AMENDMENTS TO THE DRAWINGS

REMARKS

Summary Of The Office Action & Formalities

Fig. 2

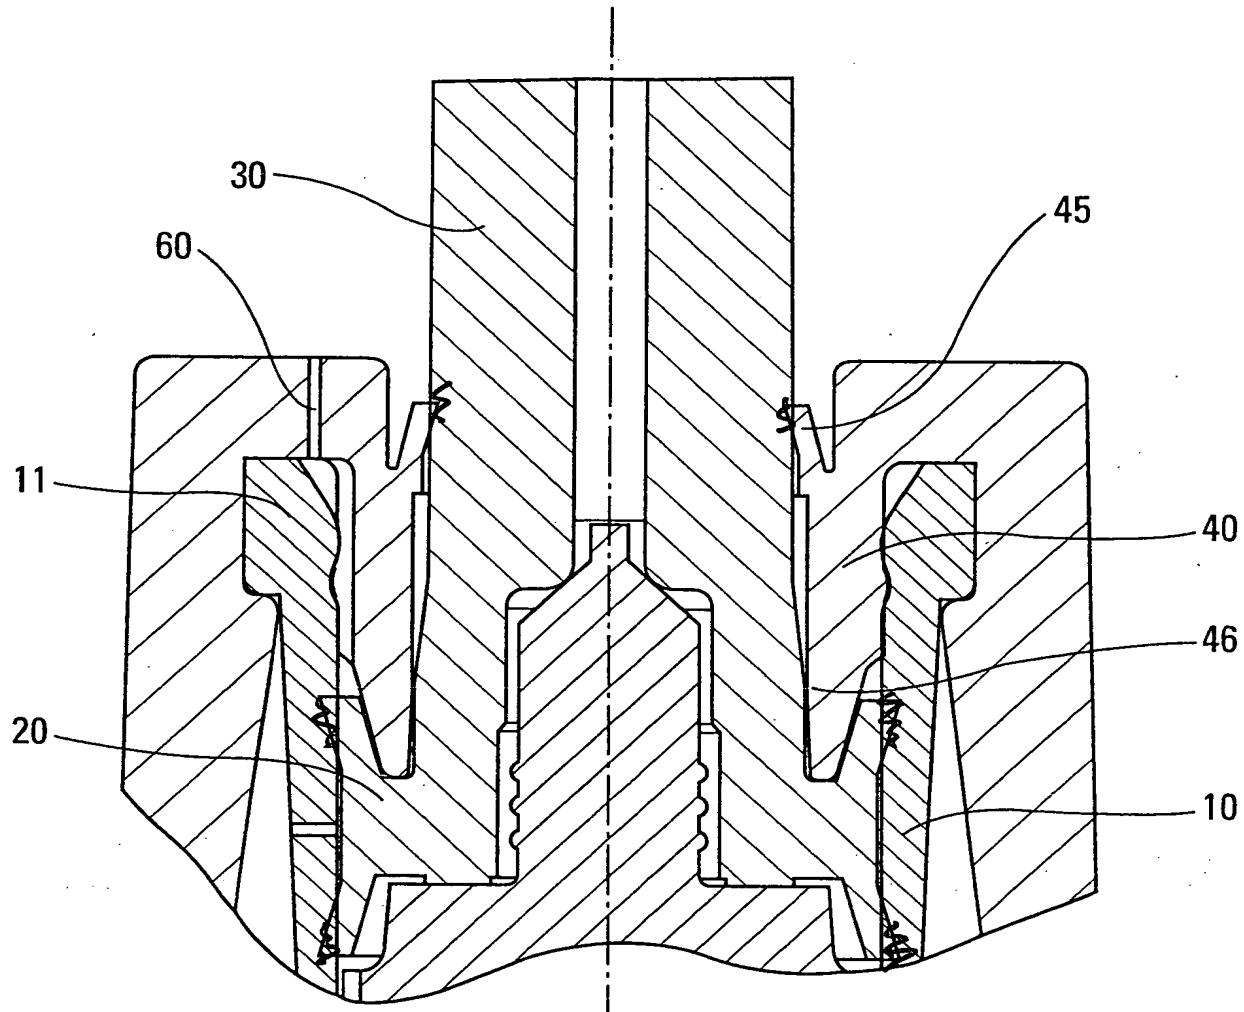
The drawings are objected to because Figure 2 shows various parts in cross section but have some of the parts drawn into adjacent parts. For example, the upper slanted region near reference number 45 goes into element 30 and the lower slanted portions of rod 30 extend into the pump body 10. Applicant is amending Fig. 2 to overcome this objection.

Figure 2 has been amended to remove the parts that the Examiner indicated are drawn into adjacent parts.
